Far East Knitting & Dyeing Industries Ltd.

East Chandara, Kaliakoir, Gazipur
(+24.042354N, +90.263318E)

06 October 2013

Building Observations

Mixed Structural Systems

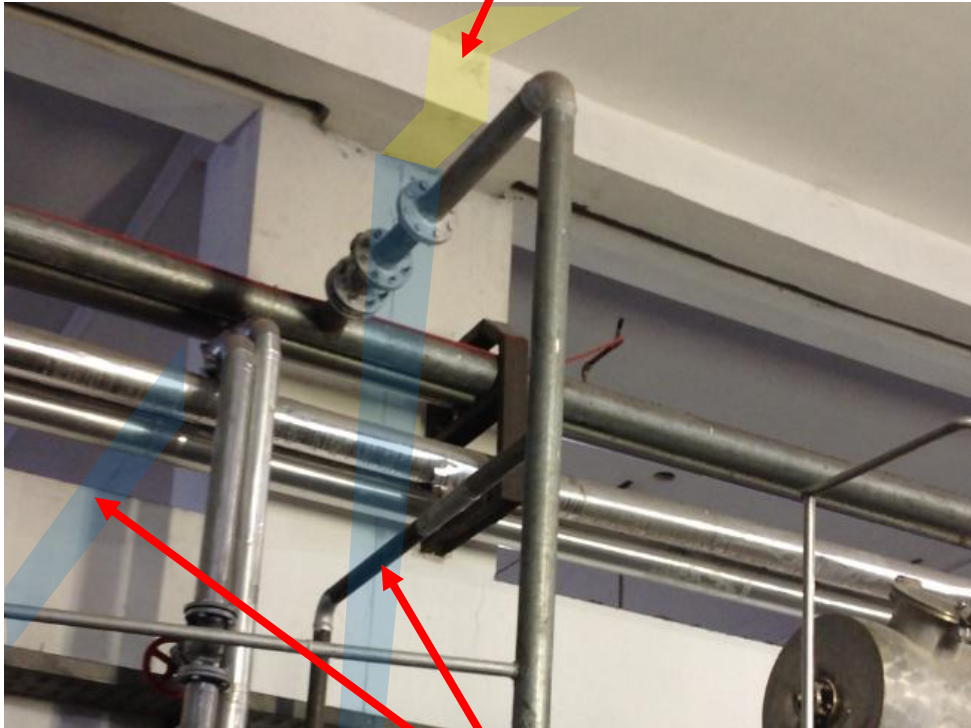
Steel structure and R.C. structure are both used interchangeably. A clear logic how the two systems work together or are separated from each other is not apparent

No Movement joint

Movement joint

Movement Joint not continuous
